North West Growth Centre water related services for first release precincts

Preferred Project Report

July 2008

Figure 1-4 Original and revised drinking water pipeline routes

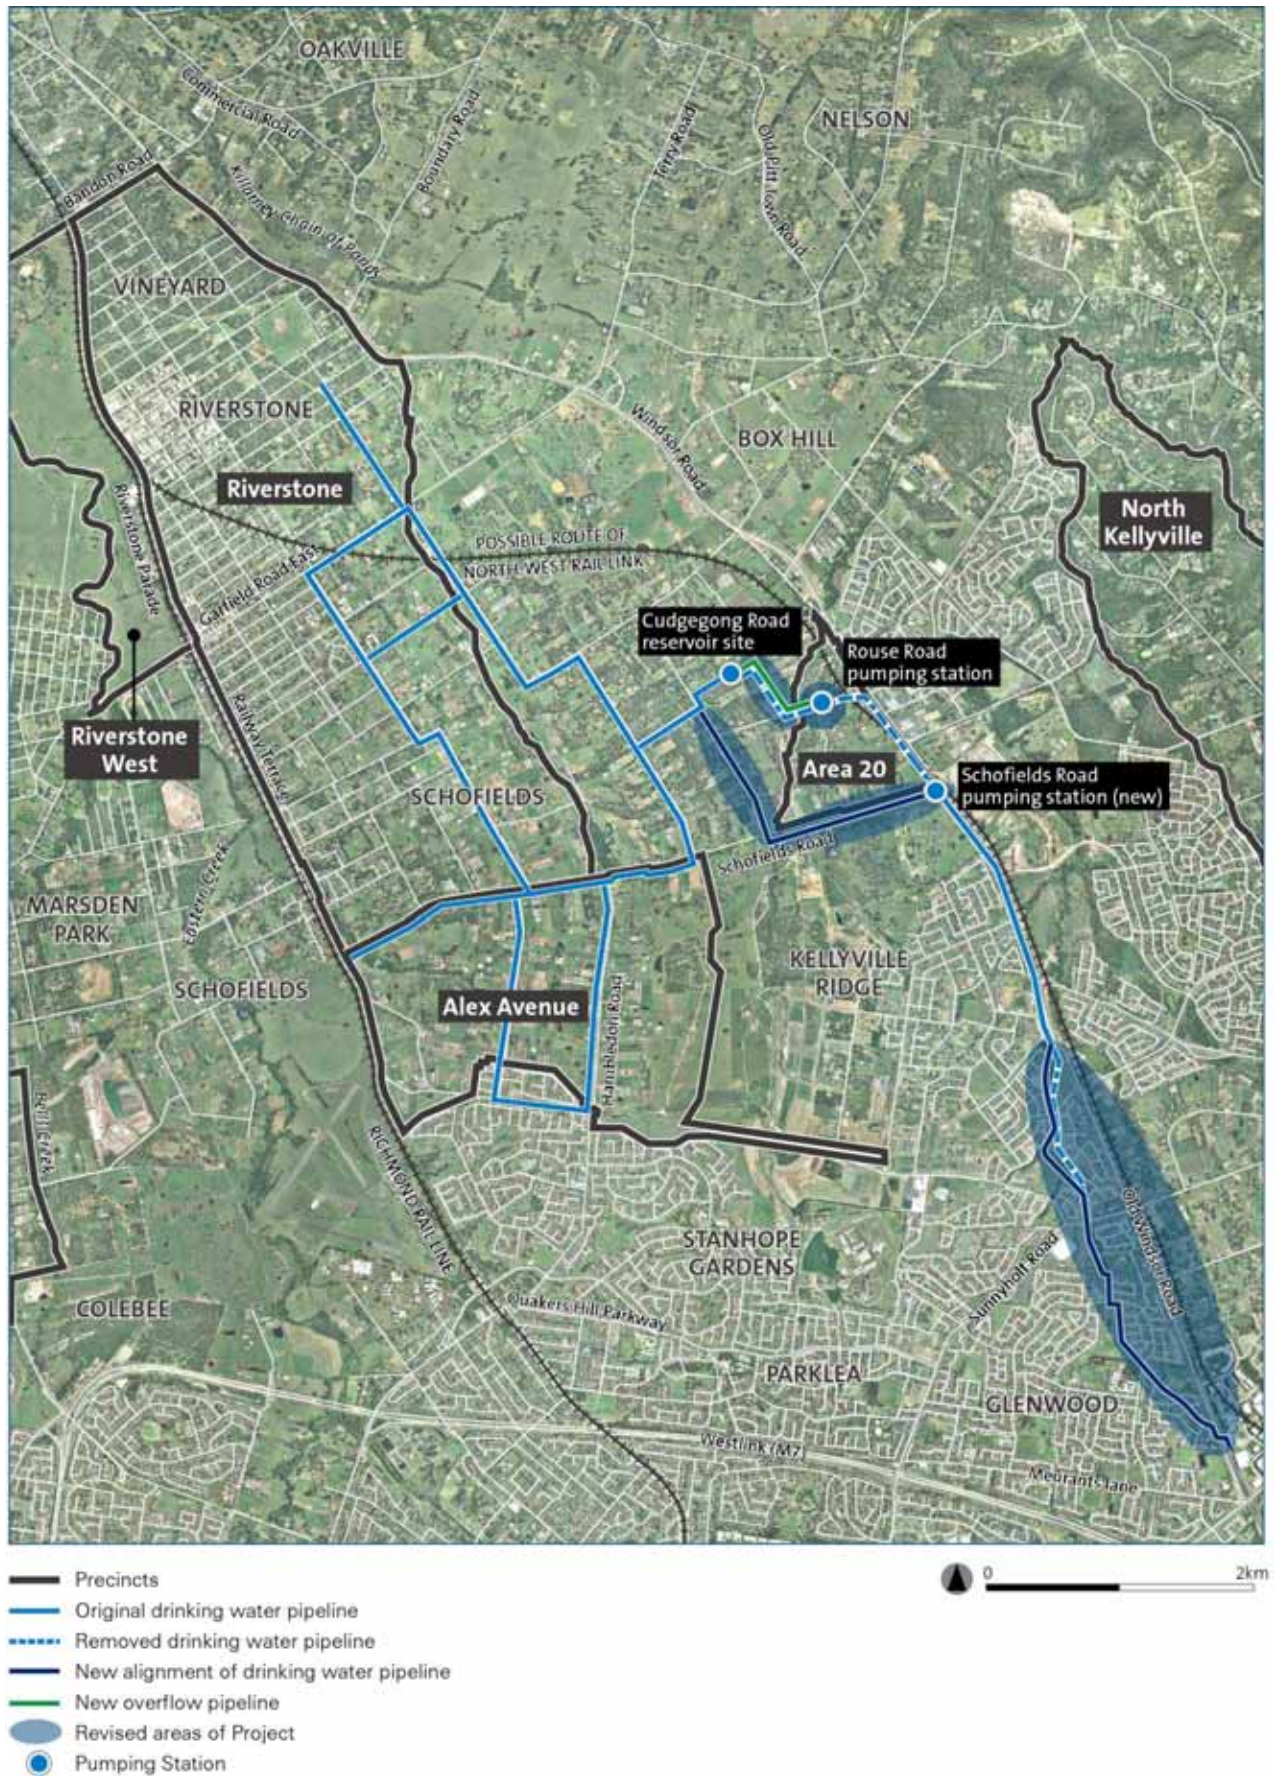
As a result of a submission from the Transport Infrastructure Development Corporation (TIDC) the drinking water pipeline route from Parklea to the Cudgegong Road Reservoir Site has been revised to avoid impacting on the proposed TIDC North West Metro rail link. The revised route would minimise the impacts on future railway infrastructure.

The revised route would also reduce the impact along Windsor Road and would provide the opportunity for the section of pipeline laid along Schofields Road to be coordinated with the proposed construction works for the widening and upgrading of Schofields Road.

During the design refinements it was determined that the drinking water pipeline should extend back to Old Windsor Road at Bella Vista to allow for ultimate servicing of the Parklea-Rouse Hill drinking water delivery system. This extension of the pipeline would generally be through existing Sydney Water owned drainage land that forms part of the Caddies Creek drainage system to Old Windsor Road.

Figure 1-4 shows the route of the revised pipeline in comparison with the original pipeline. The revised route would commence at Sunnyholt Road near Clarendon Drive and progress northward within the drainage reserve along Caddies Creek. The pipeline would enter Old Windsor Road on the western side and then continue northward along Windsor Road. The pipeline would then turn left at Schofields Road on the southern side and then turn right into Cudgegong Road. The pipeline would enter the Cudgegong Road Reservoir Site along the existing property access corridor.

Due to the relocation of the drinking water pipeline from Parklea to the Cudgegong Road Reservoir Site the proposed water pumping station at Rouse Road has also been relocated. It is now proposed to locate the new pumping station on the southern side of Schofields Road near the intersection of Windsor and Schofields Road as shown in [Figure 1-4](#).

Figure 1-5 Original and revised recycled water pipeline routes

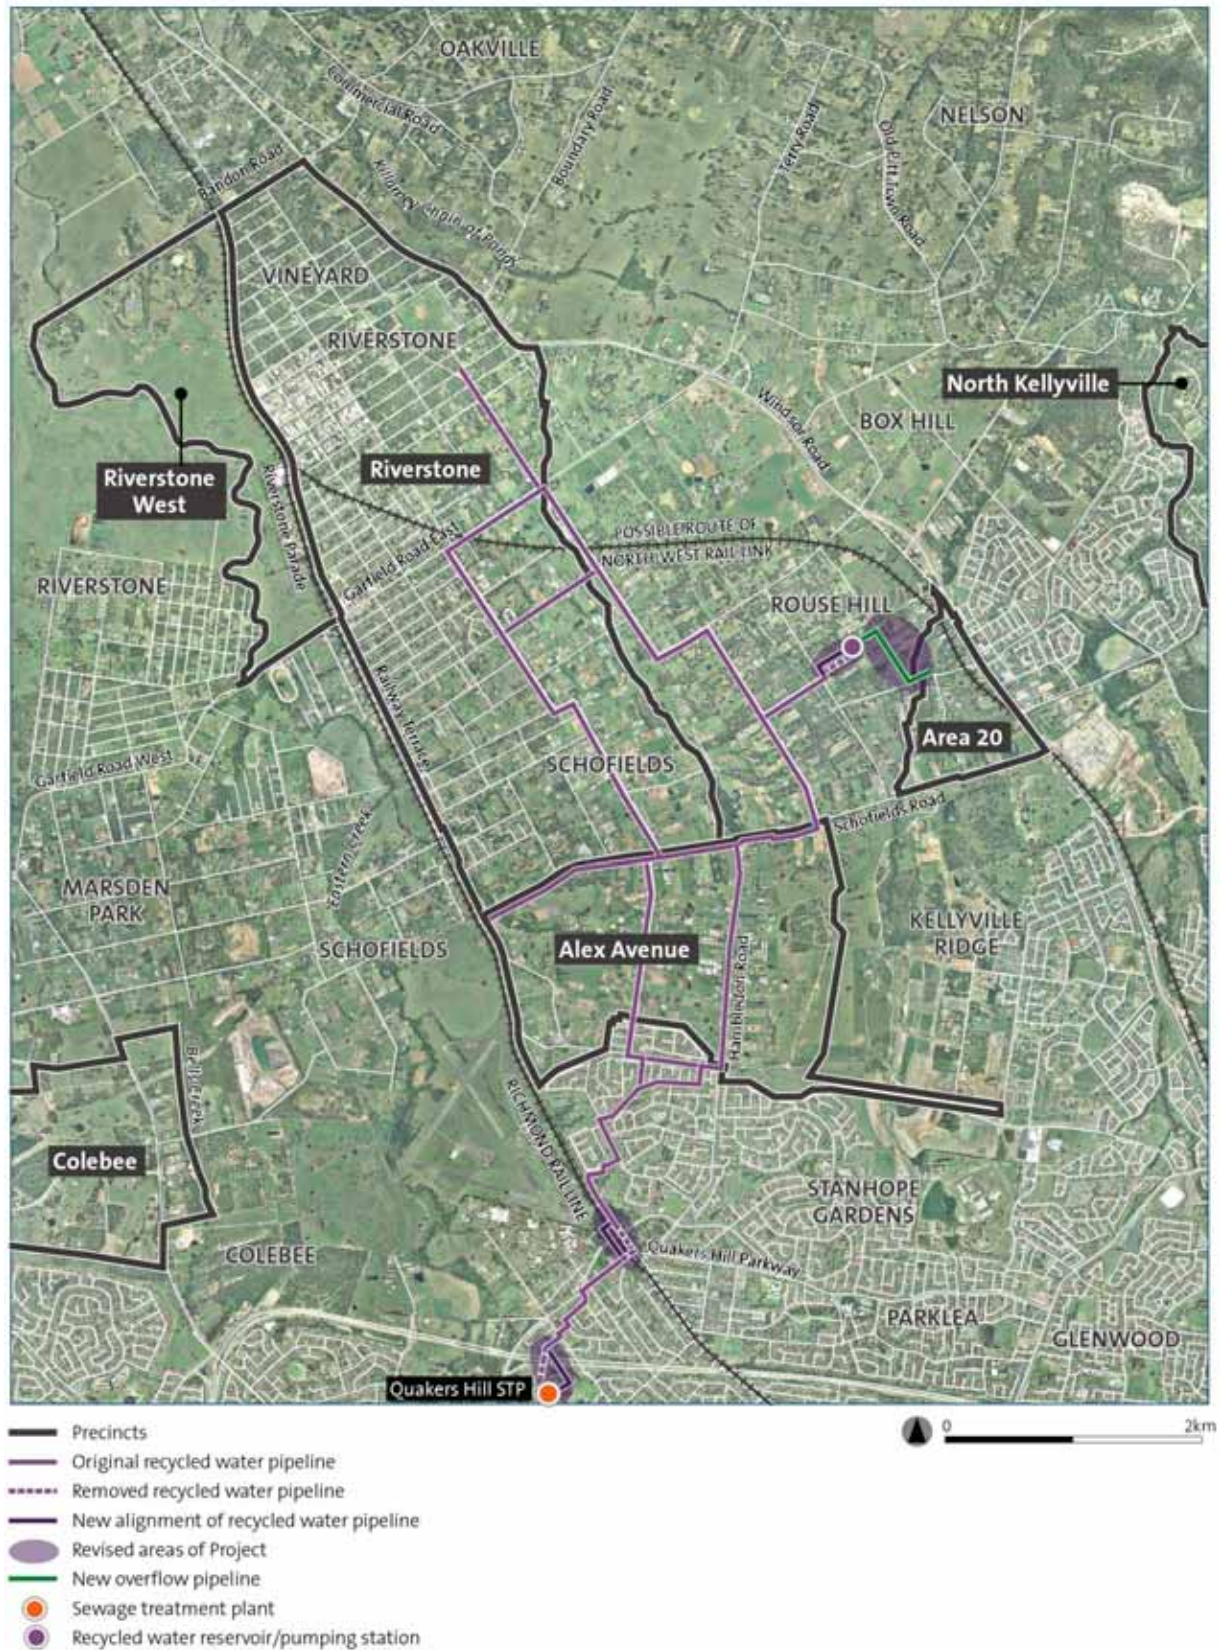
The route originally proposed for the recycled water pipeline from Quakers Hill Recycled Water Plant crossed the Richmond rail line at Oppy Reserve. This original route impacted on vegetation communities on the eastern side of the rail line at Oppy Reserve and Commonwealth owned land on the western side of the rail line. To avoid impacting the vegetation communities and Commonwealth owned land, the rail crossing has been moved about 20 metres south as shown in [Figure 1-5](#).

During investigations at the Cudgegong Road Reservoir Site it was determined that there was insufficient space for the required number of pipes along the existing access corridor. The recycled water pipelines at the Cudgegong Road Reservoir Site would utilise a second access corridor about 70 metres north as shown in [Figure 1-5](#).

The route originally proposed for the recycled water pipeline from Quakers Hill Recycled Water Plant crossed the M7 Motorway directly north of the Quakers Hill Sewage Treatment Plant. The revised recycled water pipeline would exit the Quakers Hill Recycled Water Plant along the access road to Quakers Road and then would follow Quakers Road to Quakers Hill Parkway as shown in [Figure 1-5](#). The pipeline would be bored under the M7 Motorway.

Figure 1-6 Expansion of Cudgegong Road Reservoir Site

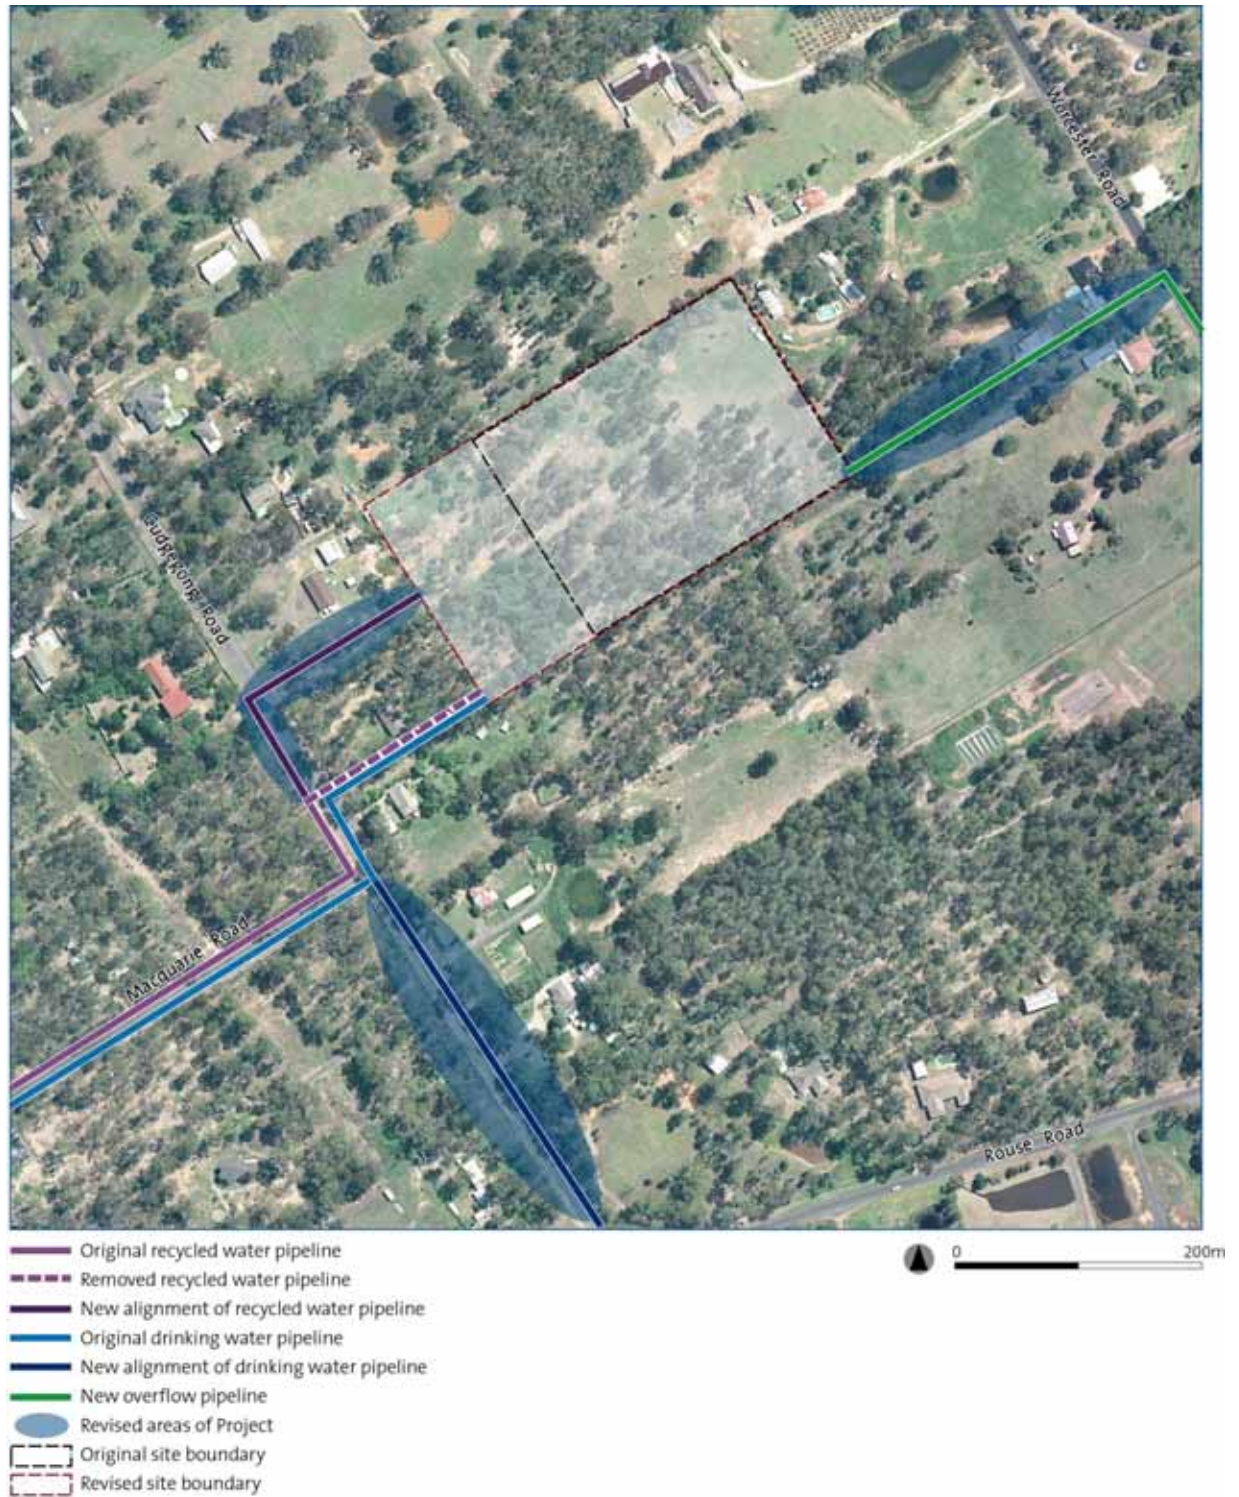
Whilst finalising the infrastructure required at the Cudgegong Road Reservoir Site some items were repositioned to accommodate additional associated reservoir infrastructure, such as access roads, servicing units and pipeline spacings. To enable the provision of all required infrastructure the property boundary of the site has been expanded to include an additional hectare of private property adjacent to the Sydney Water owned land as shown in [Figure 1-6](#).

Figure 1-7 Original and revised wastewater pipeline route

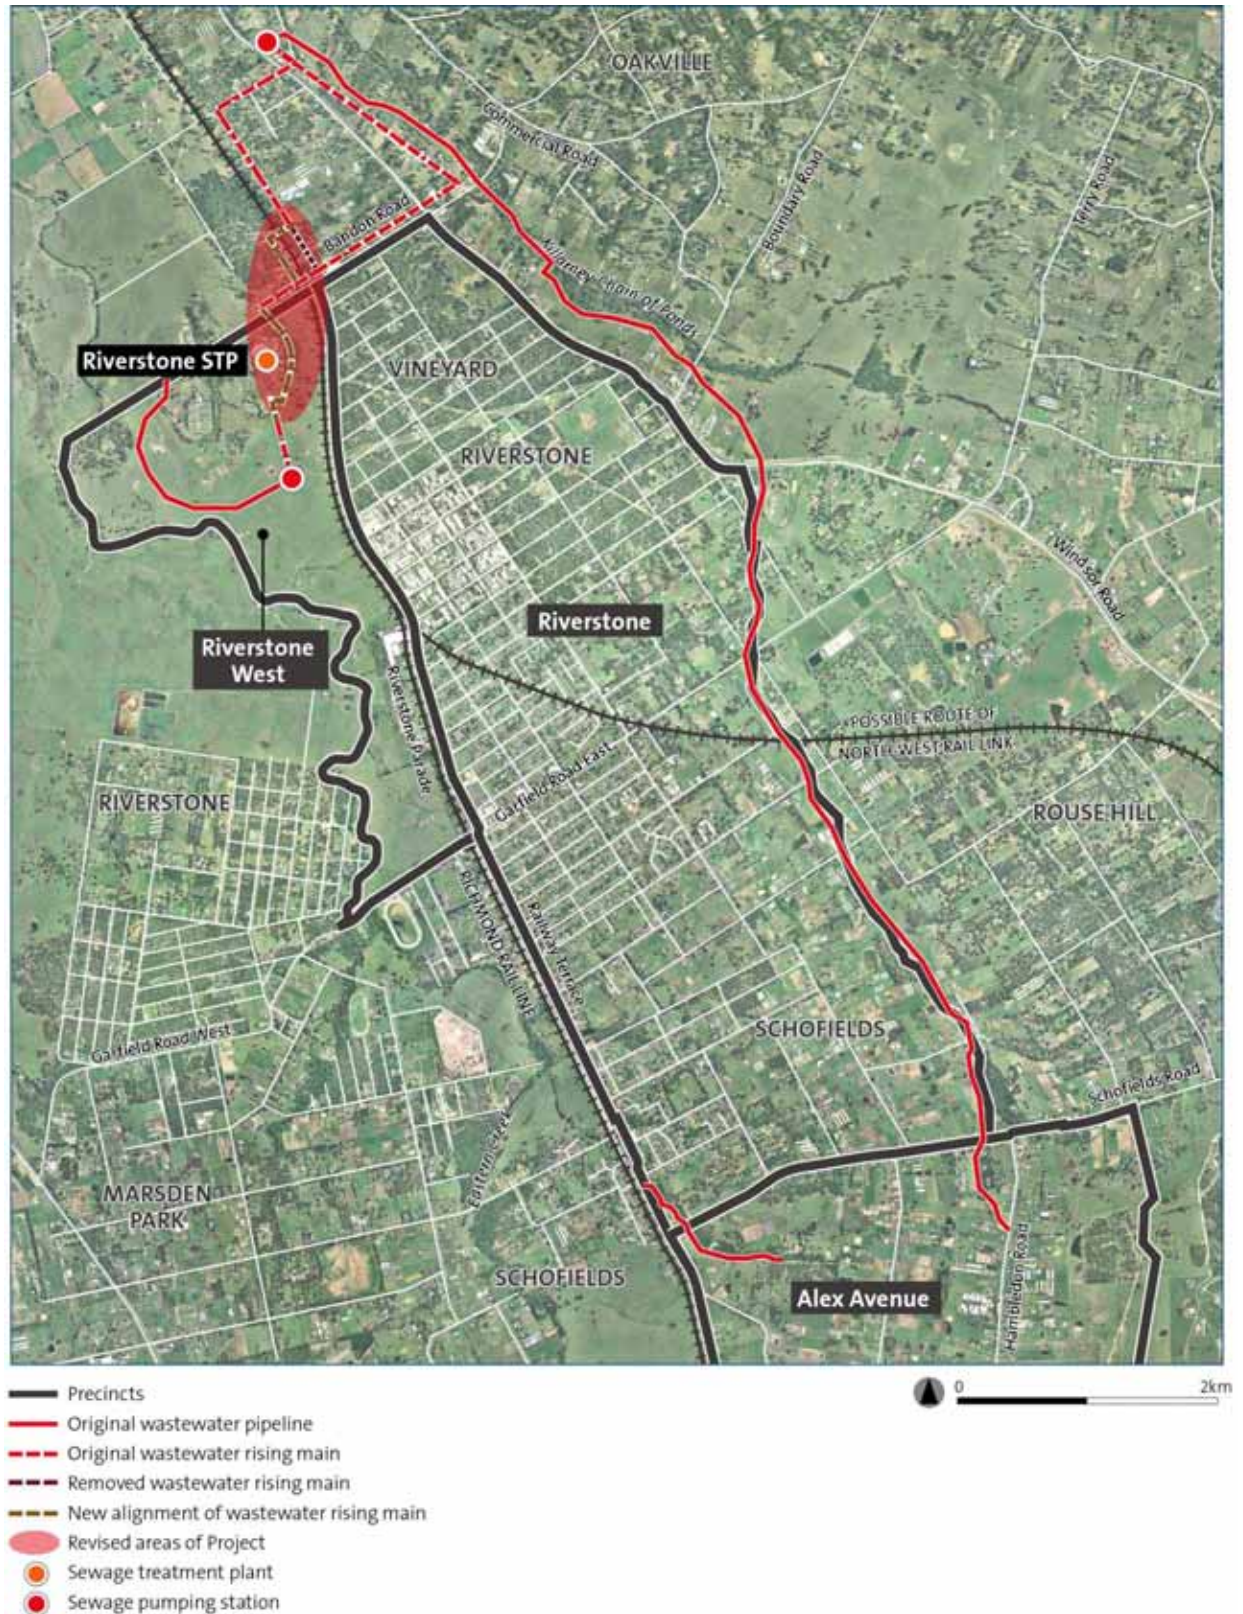
The revised Project incorporates one wastewater pipeline railway crossing at Bandon Road and one at St James Road as shown in **Figure 1-7**. It is proposed that both rail crossings would be underbored.

Figure 3-1 Odour contours for the current proposed Riverstone STP capacity

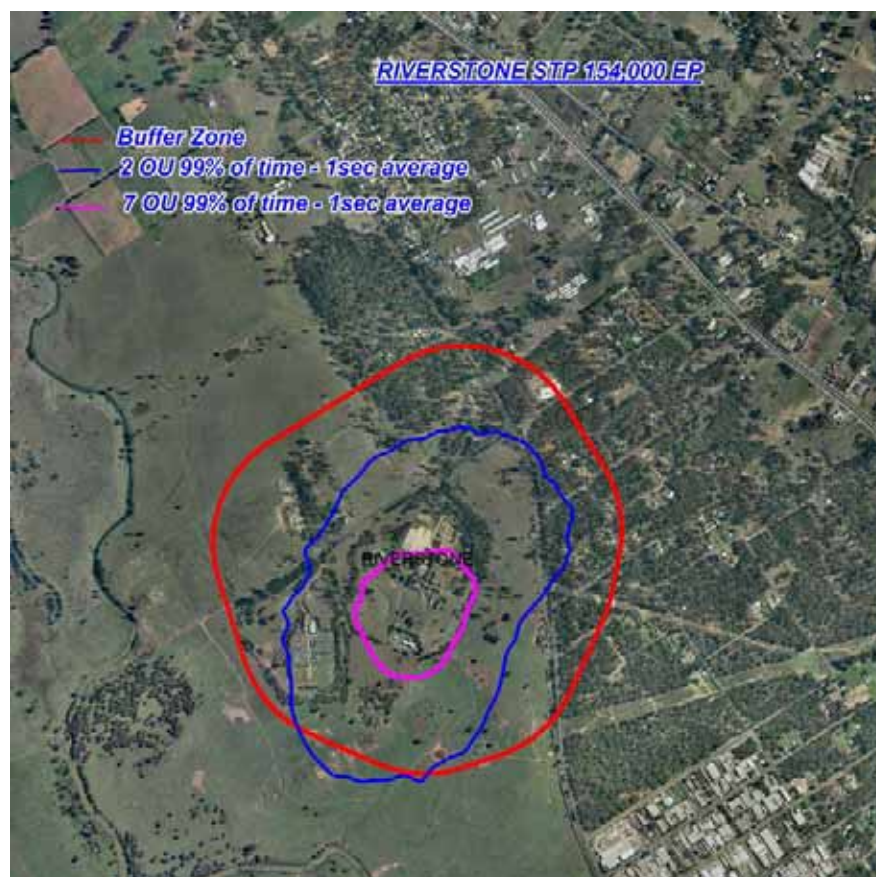
Further modelling was undertaken to clarify the odour contours as shown in **Figure 3-1** and **Figure 3-2**. The odour modelling presented was based upon the average odour emissions from the same type of process units currently planned for Riverstone STP. These data points were collected over the past 10 years. The odour sampling results were all collected during the warmer times of the year between December and May.

See **Figure 3-1** and **Figure 3-2**.
